**Meeting of the Central Valley Flood Protection Board  
April 24, 2015**

**Staff Report**

**California High Speed Rail Authority  
High-Speed Rail Bridge across Fresno River, Madera County**

Attachment E\_Typical Project Design Cross Sections

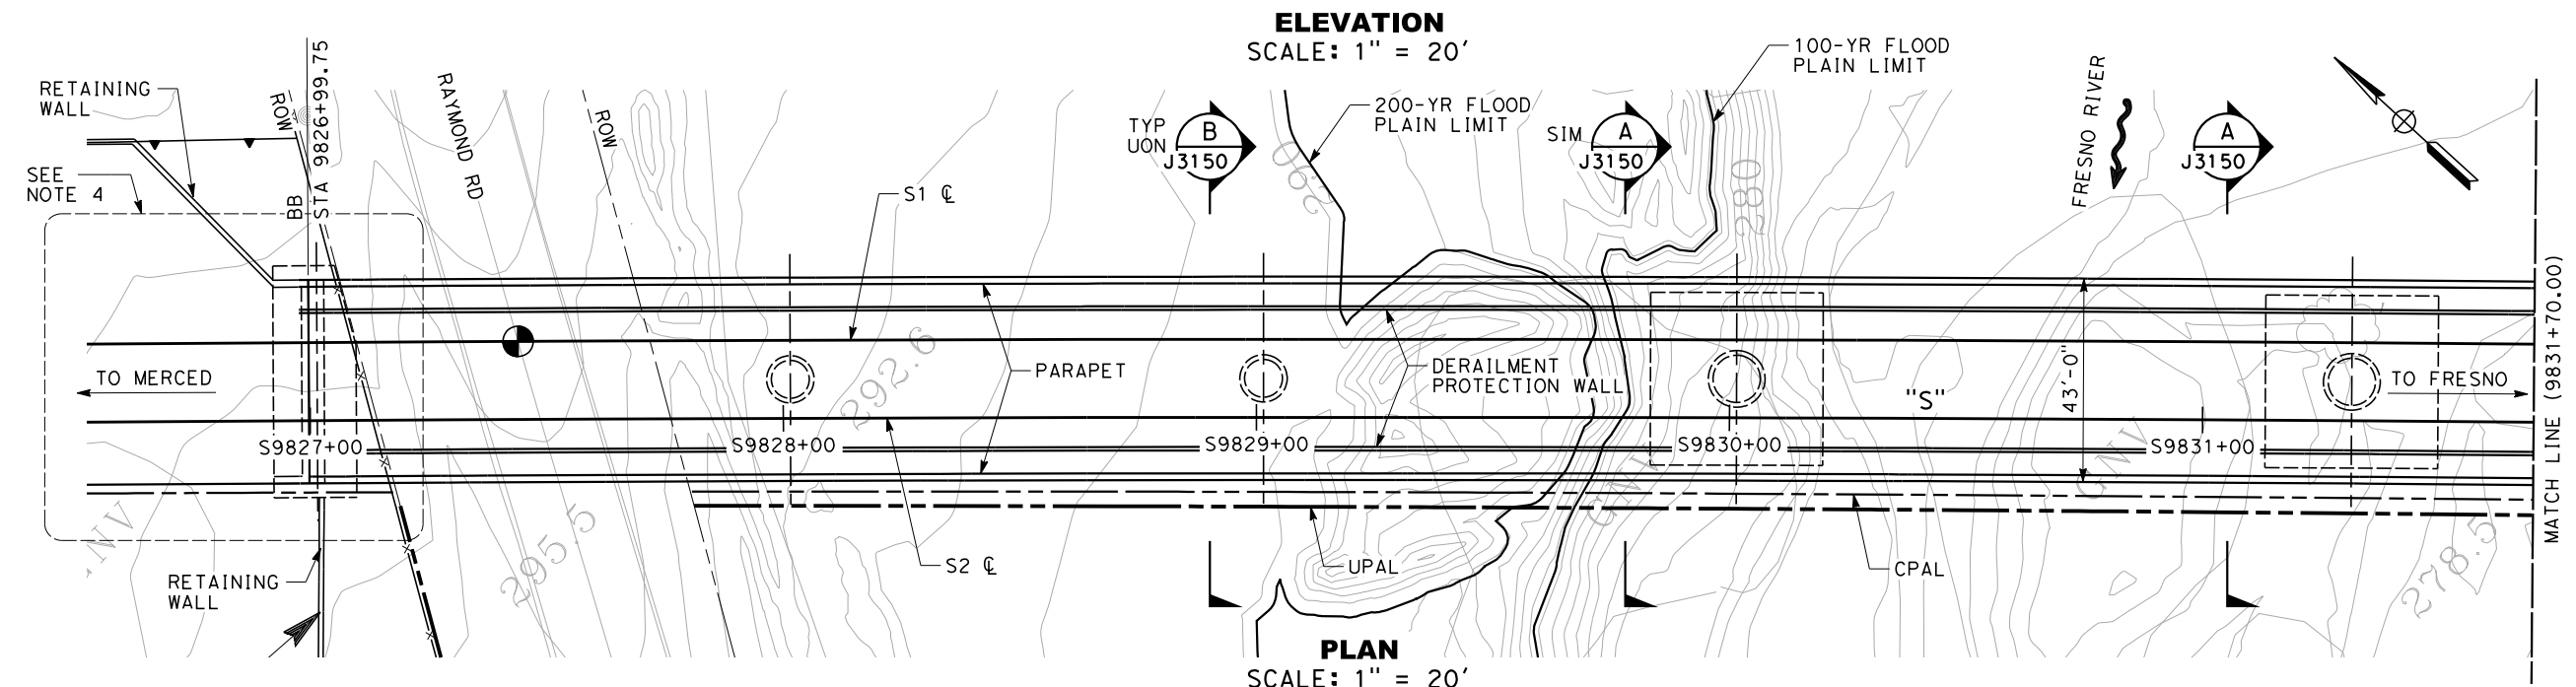
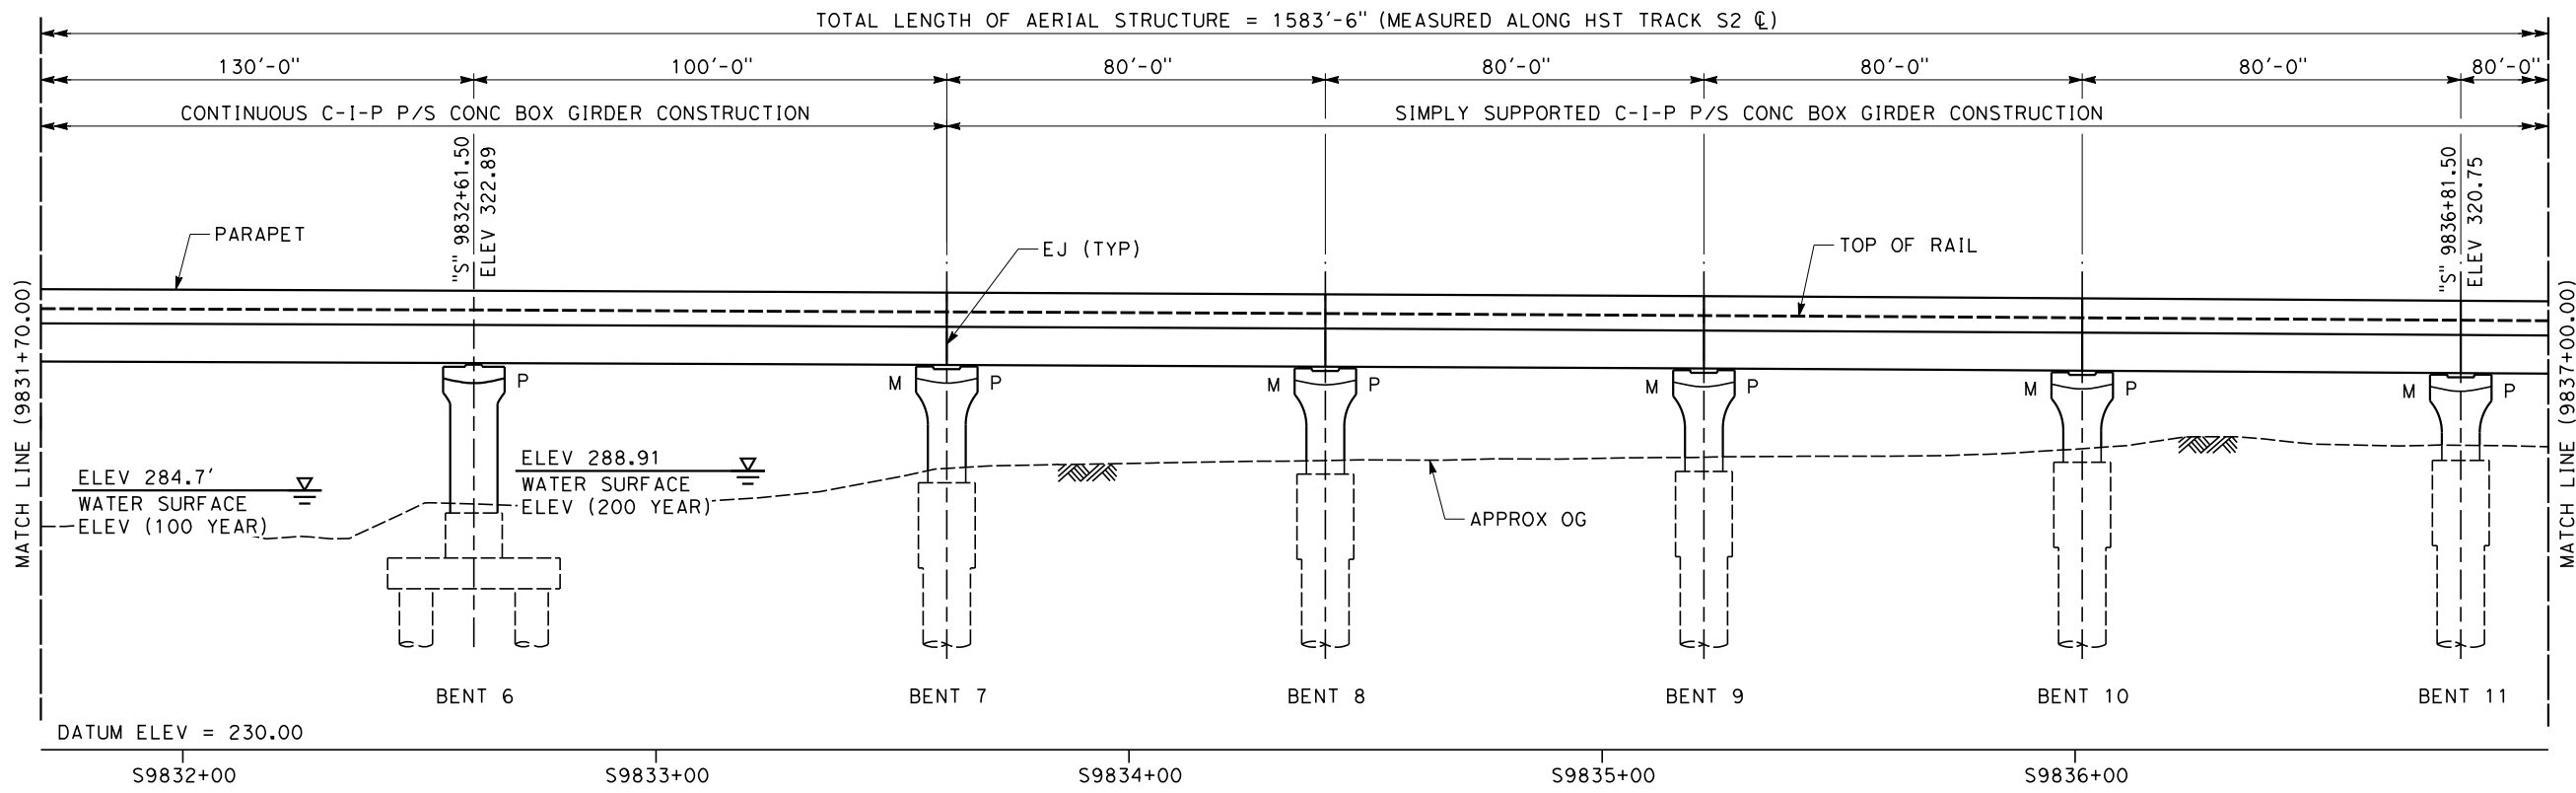
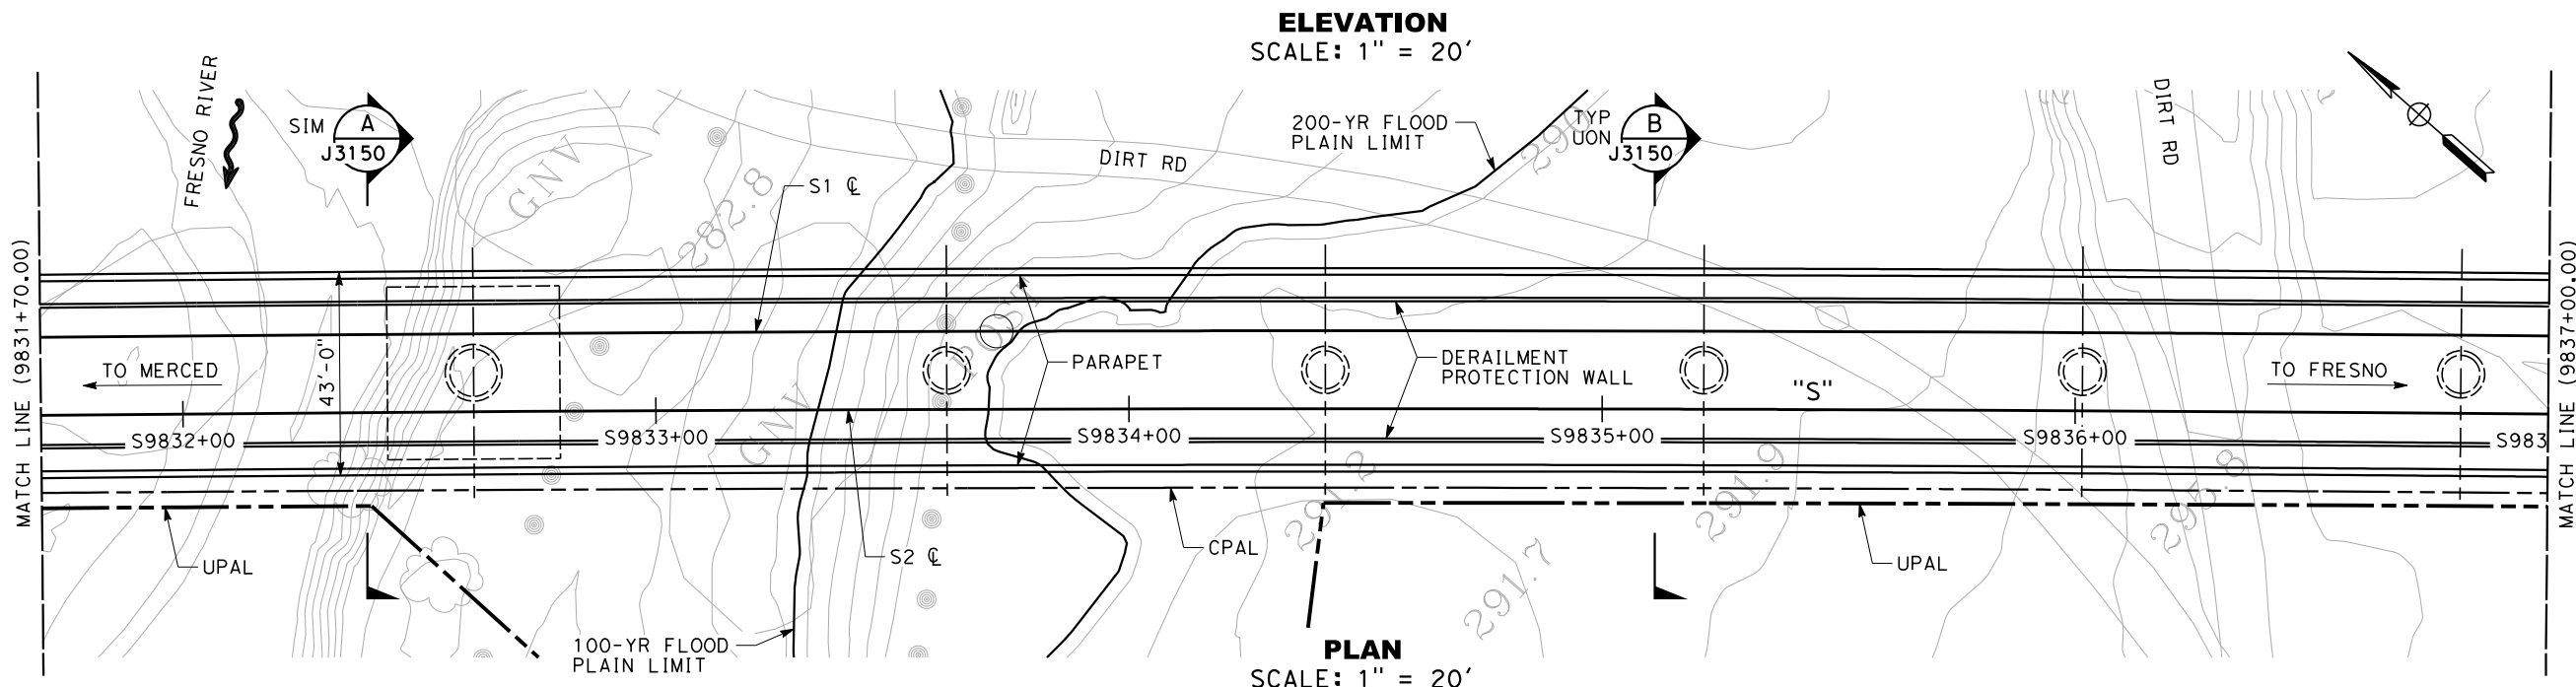
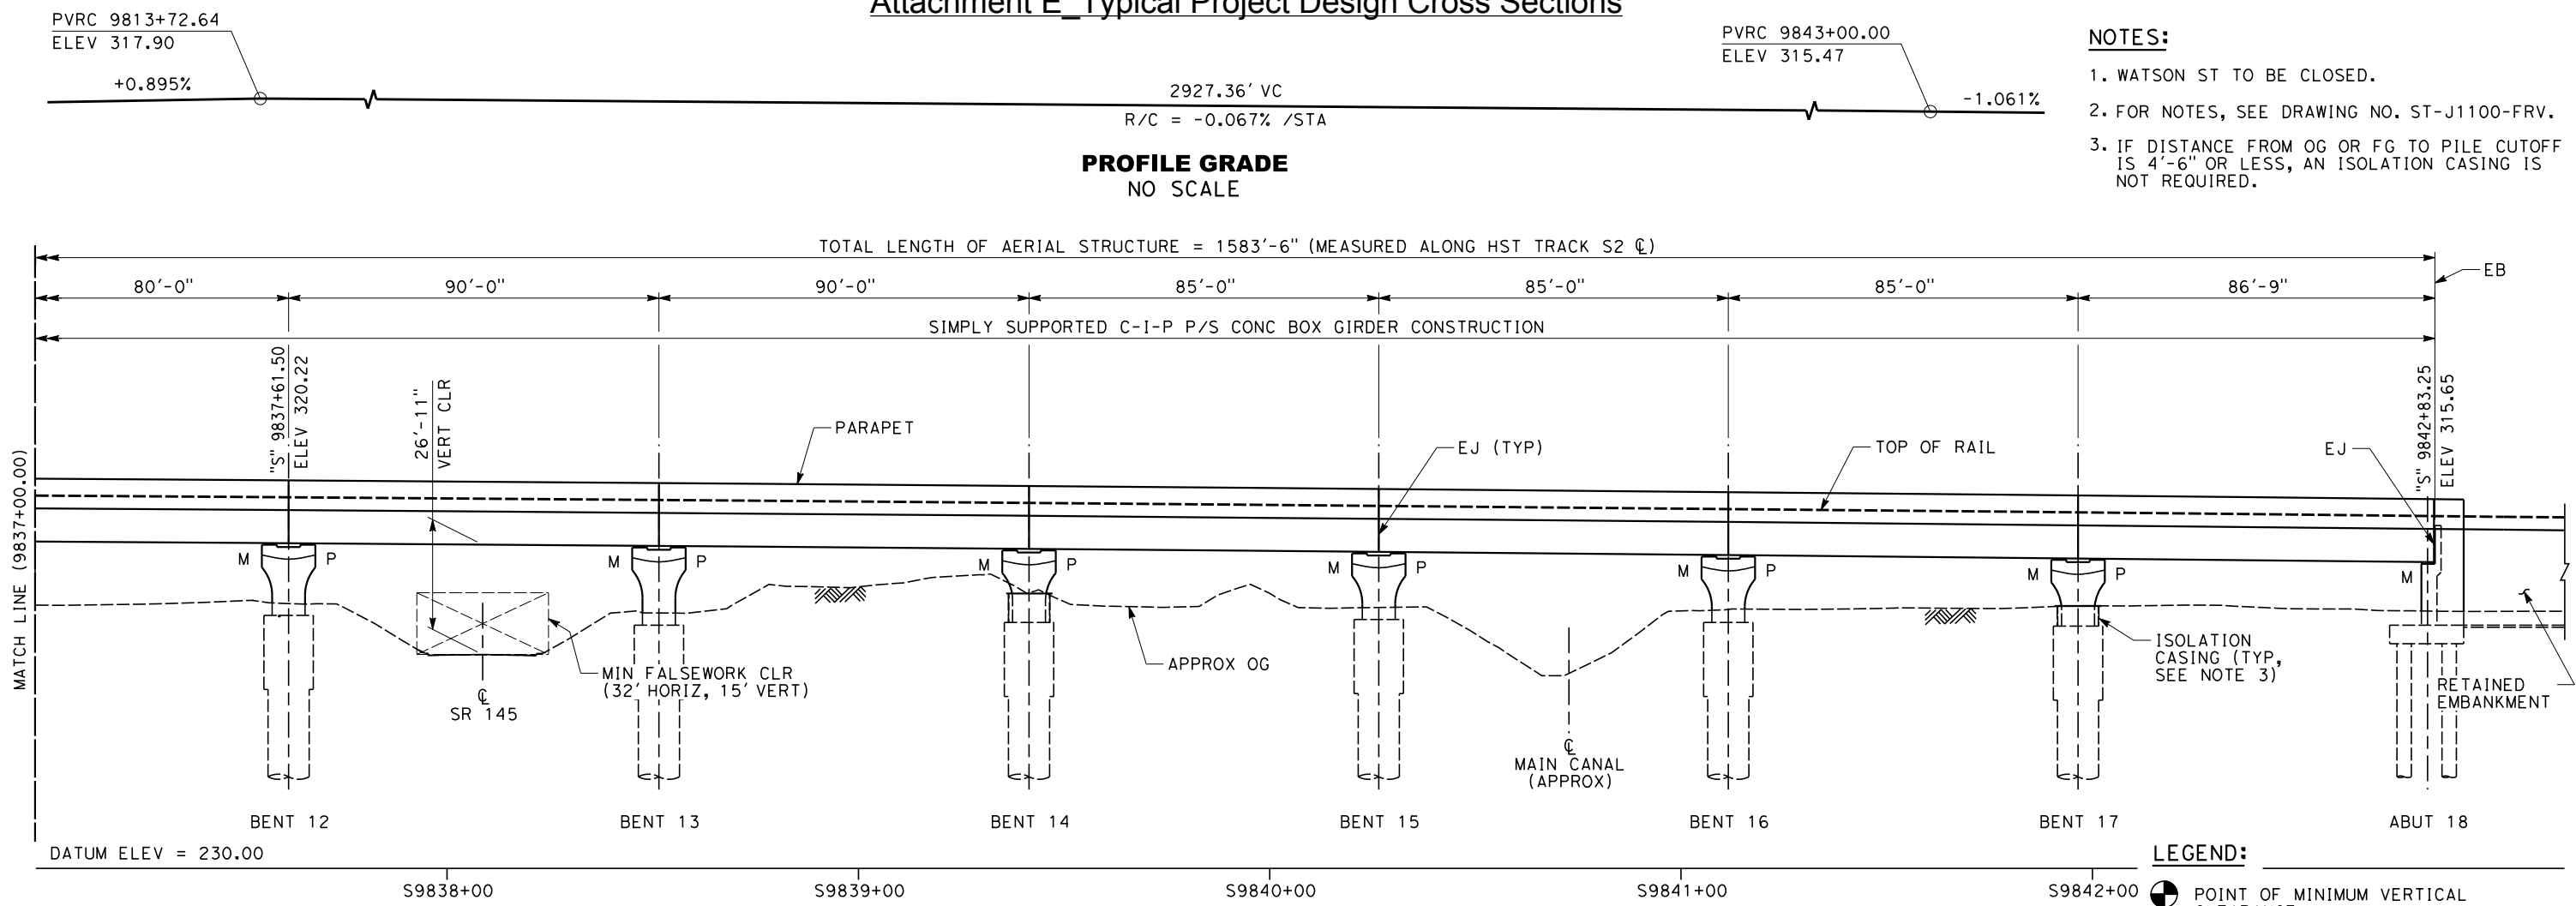
Even at the FEMA-established flow rate for the 500-year storm, the proposed HST bridge will provide 18.4 ft of freeboard. The structure will adequately meet freeboard requirement of passing the 200-year design discharge with 3 ft of freeboard.

The foundations of the piers and abutments should be installed below the estimated scour depths. Per the FHWA's HEC-18, the top of the pier footing should reference the thalweg of the channel and should be placed below the sum of the long-term bed elevation change and contraction scour. Based on the complex pier scour equations, in order to minimize the local scour, WRECO has determined recommended top of pile cap elevations for Bents B4, B5, and B6. The bottom of the pier footing should be below the total scour line. All piers were designed to the same elevation due to potential channel thalweg migration.
